ATTACHMENT 1

Letter from M.L. Marchi (WPSC)

September 28, 1998

Proposed Amendment 152a

FIGURE TS 2.1-1

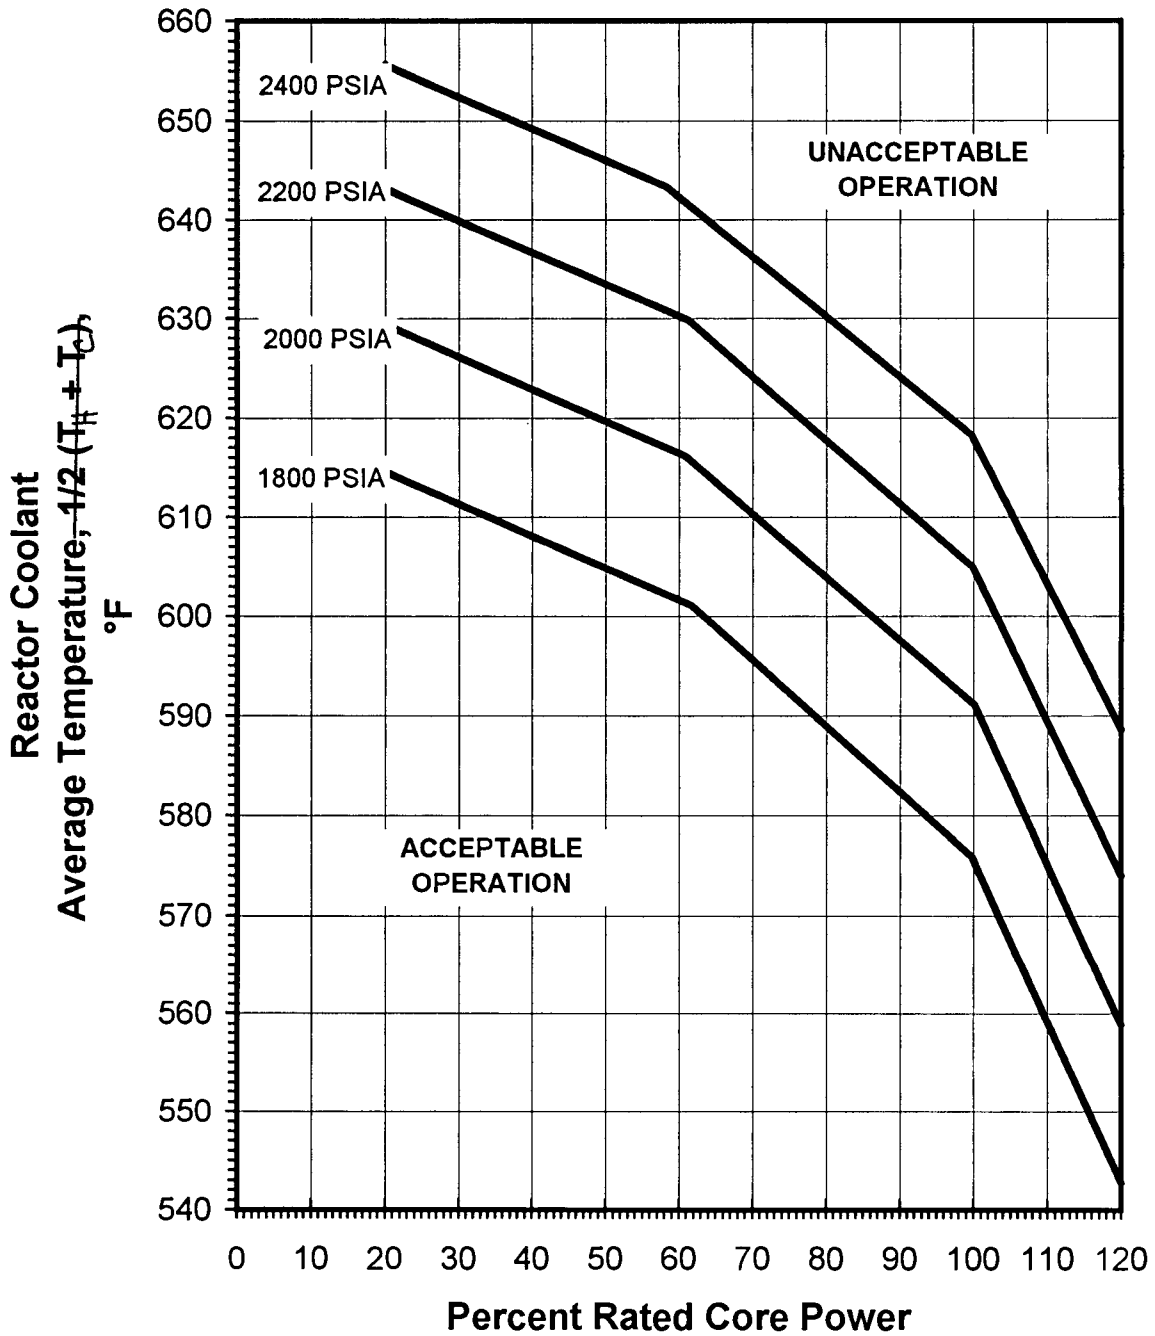
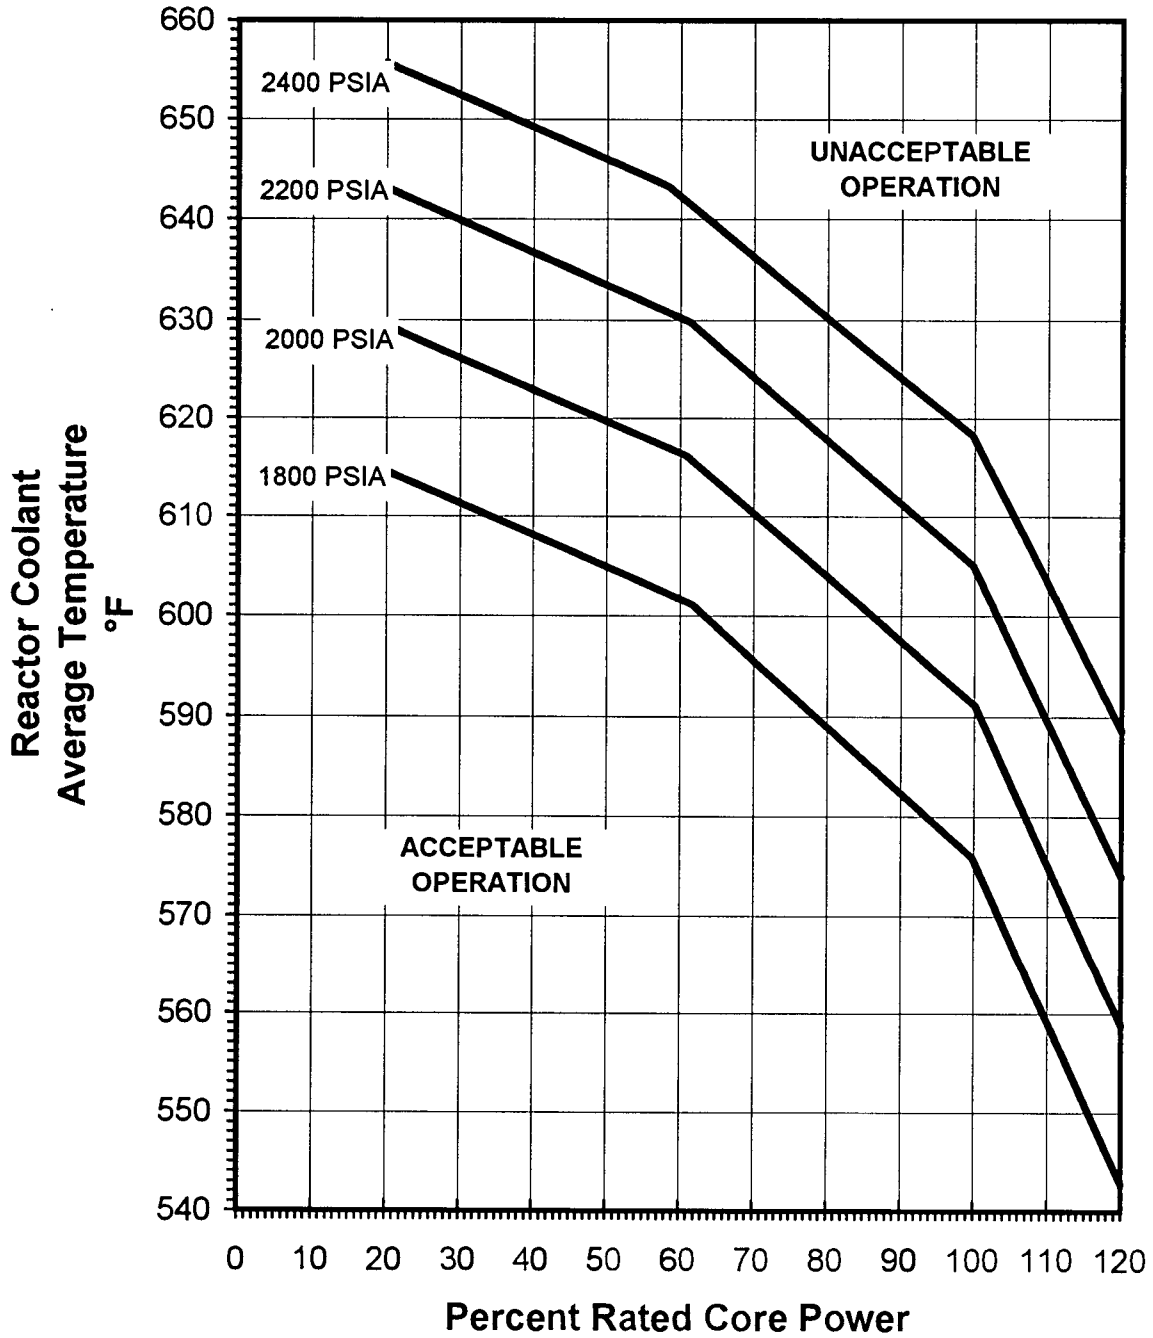
- 1) Figure 2.1-1 is revised to reflect the recently approved High Thermal Performance (HTP) Critical Heat Flux (CHF) correlation and corresponding Departure from Nucleate Boiling Ratio (DNBR) limit of 1.14. The figure also reflects changes in peak rod power and minimum reactor coolant flow.

#### Safety Evaluation for Proposed Change to Figure TS 2.1-1 and TS B2.1

The Departure from Nucleate Boiling (DNB) correlation and the associated Minimum DNBR limit were changed in this section. Additionally, the minimum reactor coolant flow and corresponding peaking factor limits were changed. The new safety limits curves are a result of changes to DNBR limit, Critical Heat Flux (CHF) correlation, Reactor Coolant System (RCS) flow, peaking factors and fuel design. The new curves will bound operation with Siemens Power Corporation standard or heavy fuel. A safety evaluation for the change to the CHF correlation was previously performed and approved (Reference 4).

The revised safety limit curves have been developed using operating parameters at their bounding values (e.g., rod powers at the peaking factor limits, reactor coolant flow at the minimum operating limit). The revised curves will bound plant operation with Siemens Power Corporation standard or heavy fuel. Therefore, this change will not involve a significant reduction in safety margin.

**FIGURE TS 3.10-1**

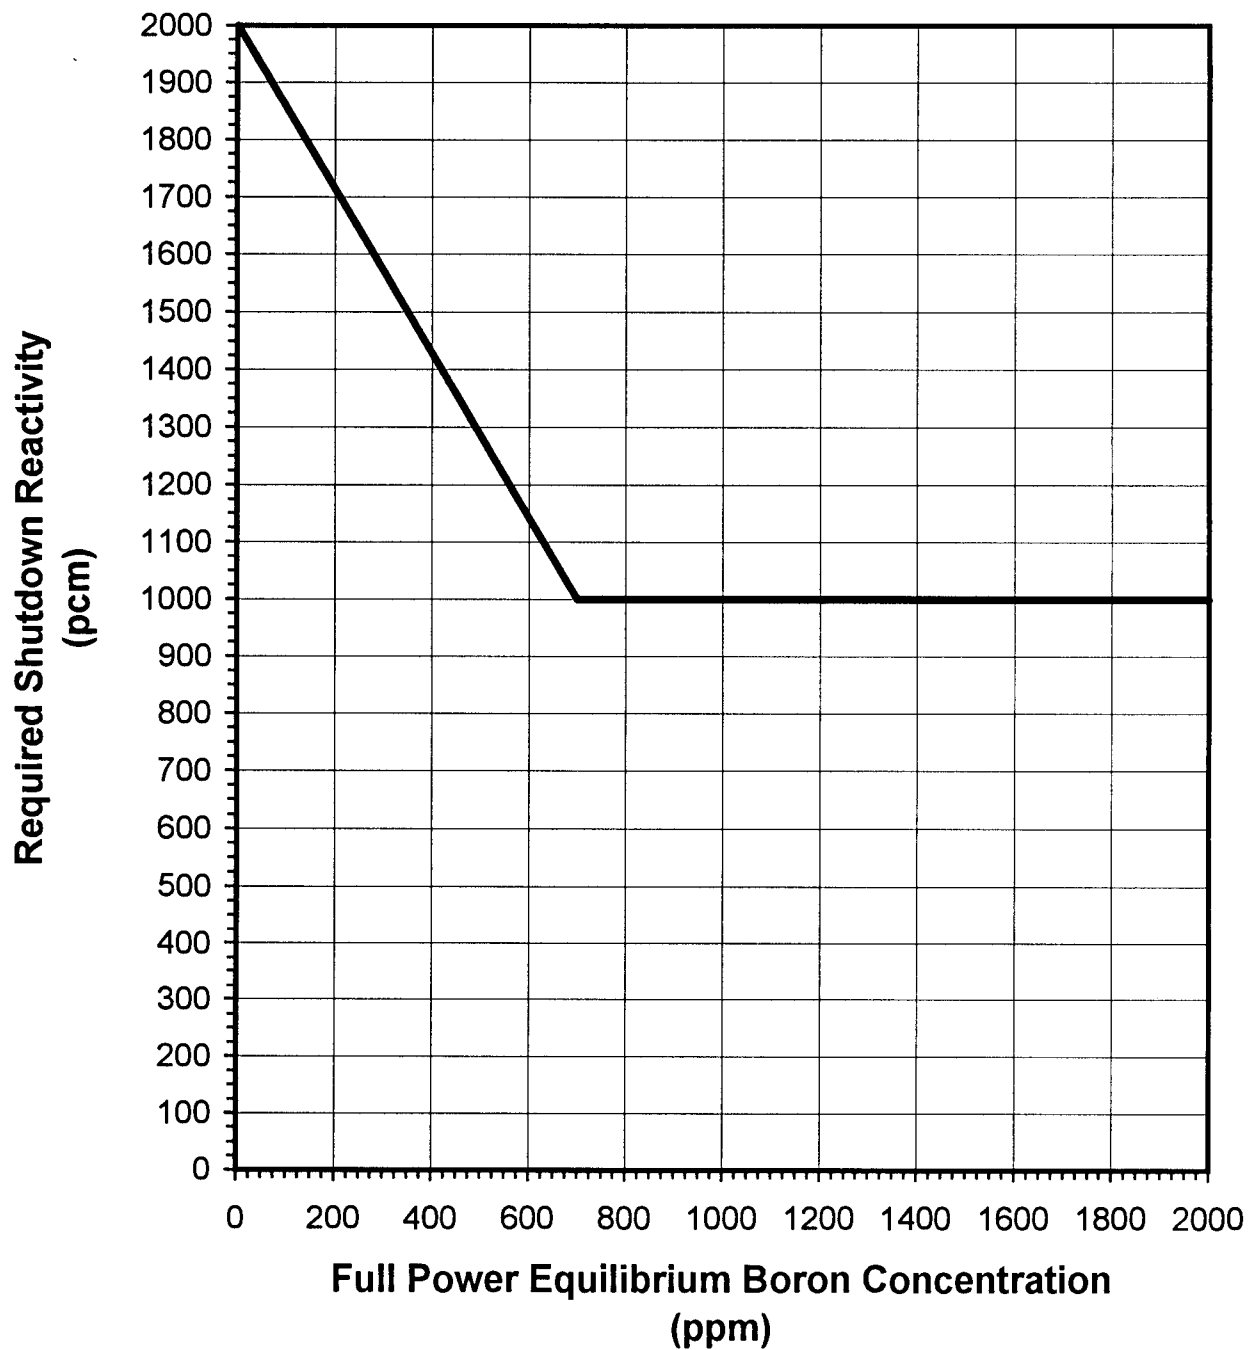
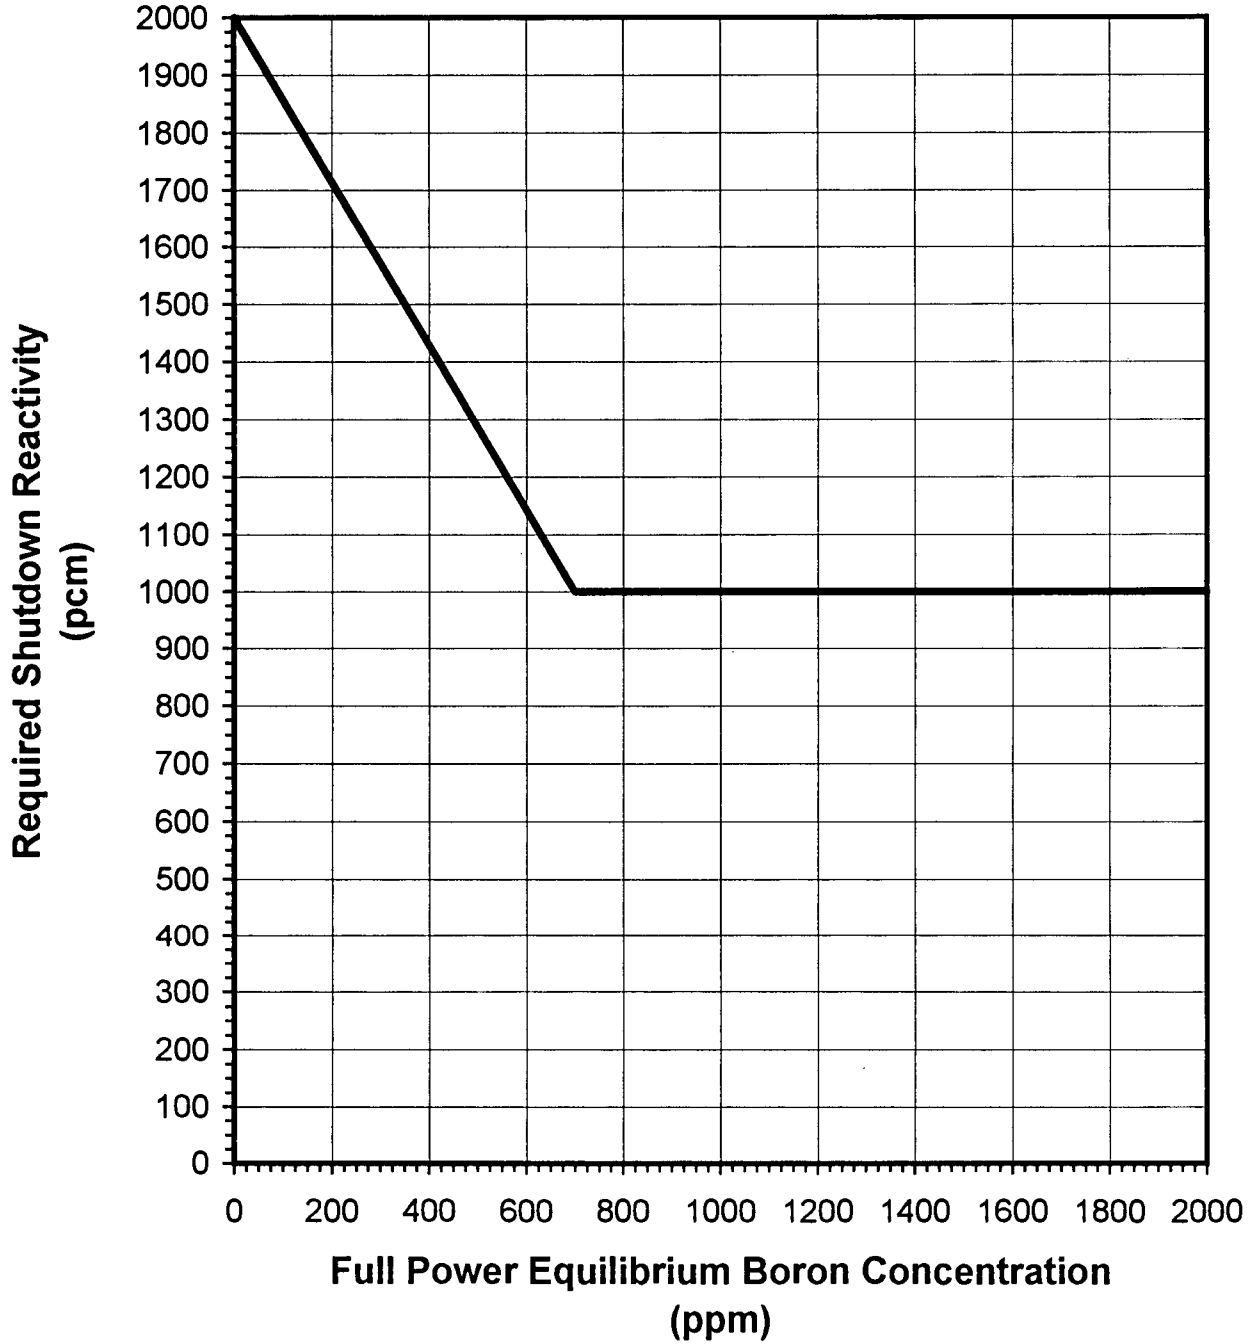
### Safety Evaluation for Proposed Change to TS Figure 3.10-1

This figure of the Technical Specifications for Required Shutdown Reactivity vs. Boron Concentration was revised to reflect the values used in the safety analyses. The limits for the shutdown margin were not changed. The boron concentration values were extended to account for the longer fuel cycles.

This change is administrative. The required shutdown reactivity line was extended from 1300 ppm to 2000 ppm. The existing values on the figure are not changed in the analysis or in the Technical Specifications. Therefore, the change will not affect the health and safety of the public.

FIGURE TS 3.10-2

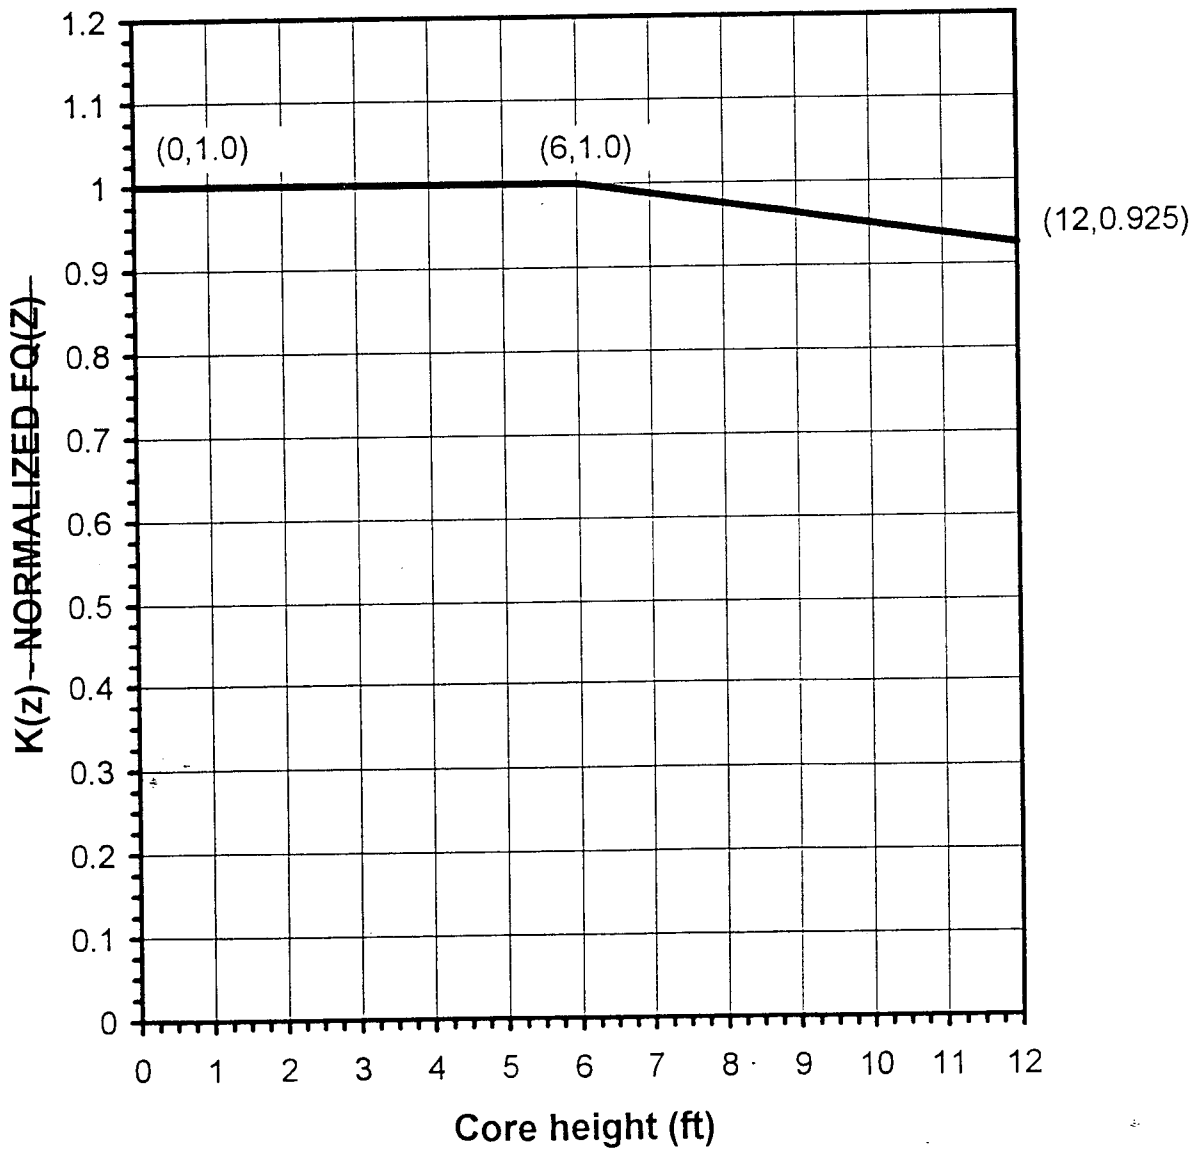
### Safety Evaluation for Proposed Change to TS Figure 3.10-2

This technical specification figure for Hot Channel Factor Normalized Operating Envelope was revised to reflect the values used in the safety analyses.

Siemens Power Corporation Fuel
K(Z) Coordinates
P1 (6, 1.0)
P2 (10.84, 0.938)
P3 (12, 0.438)
Normalized to 2.28
